<b>Well Name:</b> NW CHA CHA	<b>Well Location:</b> T29N / R14W / SEC 20 / NENE / 36.71724 / -108.32452	<b>County or Parish/State:</b> SAN JUAN / NM
<b>Well Number:</b> 11	<b>Type of Well:</b> OTHER	<b>Allottee or Tribe Name:</b> SHIPROCK
<b>Lease Number:</b> 14206032200A	<b>Unit or CA Name:</b>	<b>Unit or CA Number:</b>
<b>US Well Number:</b> 3004508142	<b>Operator:</b> HILCORP ENERGY COMPANY

**Type of Action:** Plug and Abandonment

**HILCORP ENERGY COMPANY**  
**NW CHA CHA UNIT 11**  
**P&A NOI**

## CONDITIONS OF APPROVAL

## NW CHA CHA UNIT 11 - PROPOSED WELLBORE SCHEMATIC

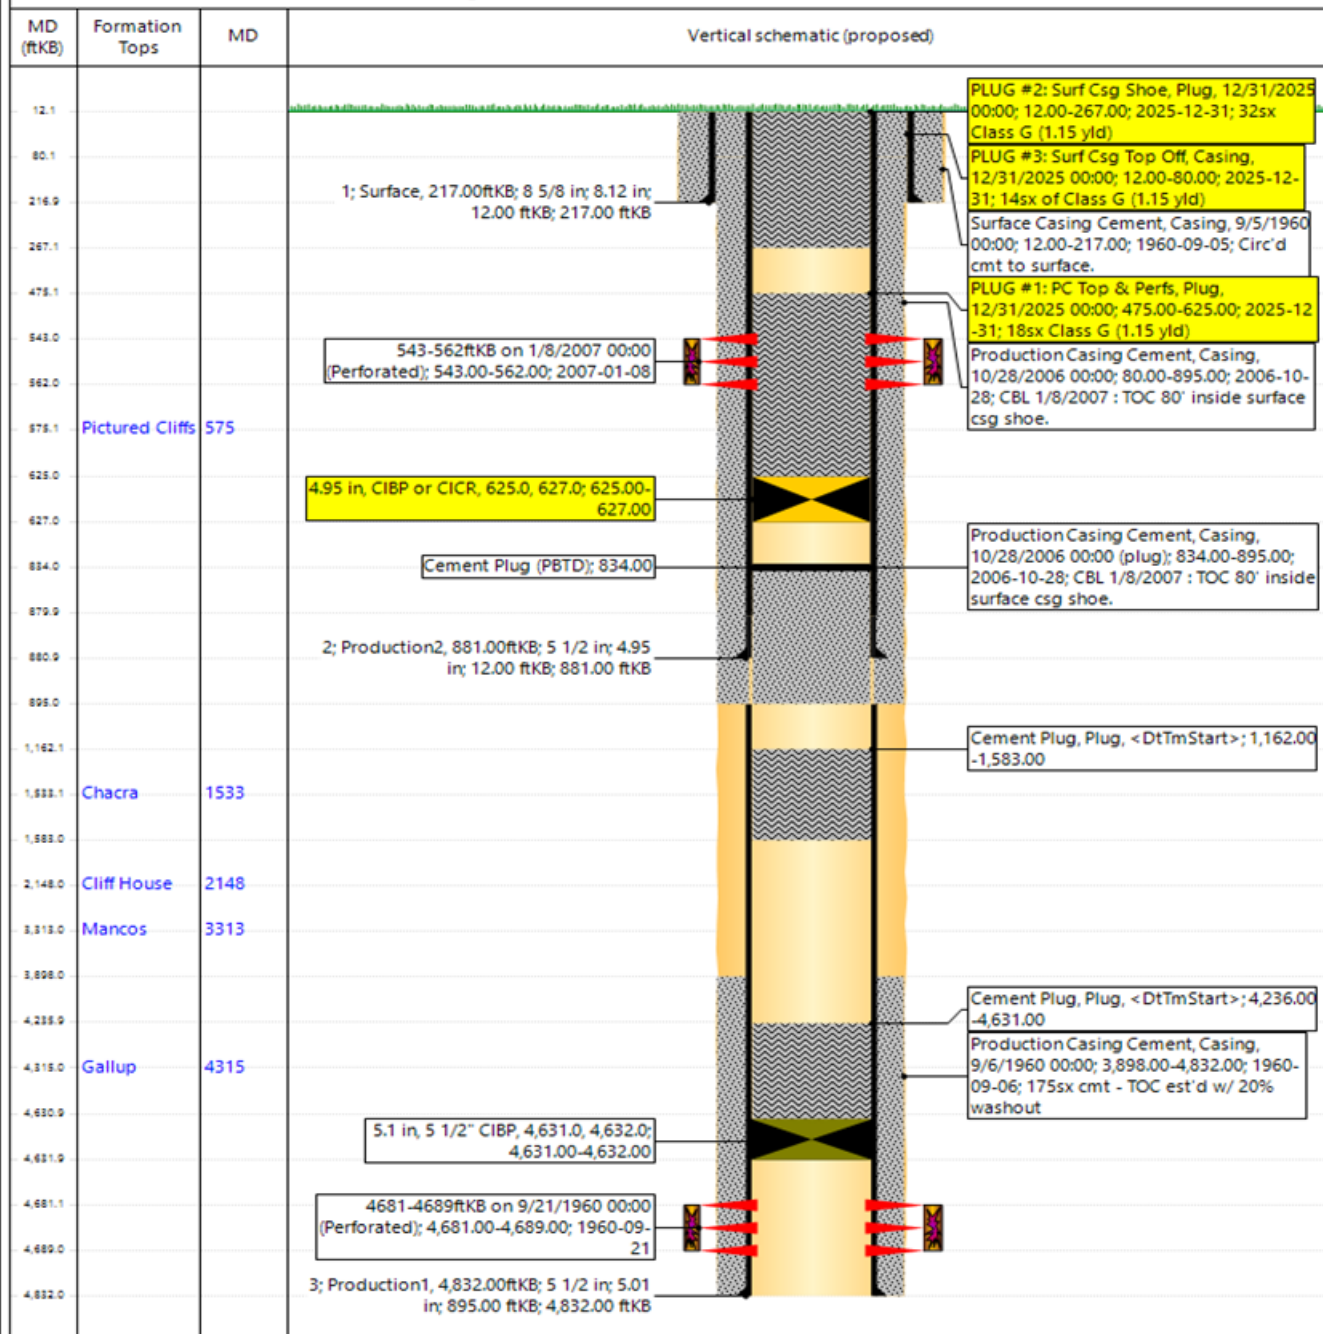
1. Plugging operations authorized are subject to the attached "General Requirements for Permanent Abandonment of Wells on Federal and Indian Lease."
2. The following modifications to your plugging program are to be made:
  - a. No changes to the procedure.
3. **Notification:** Farmington Office is to be notified at least 24 hours before the plugging operations commence at (505) 564 7750.

You are also required to place cement excesses per 4.2 and 4.4 of the attached General Requirements.
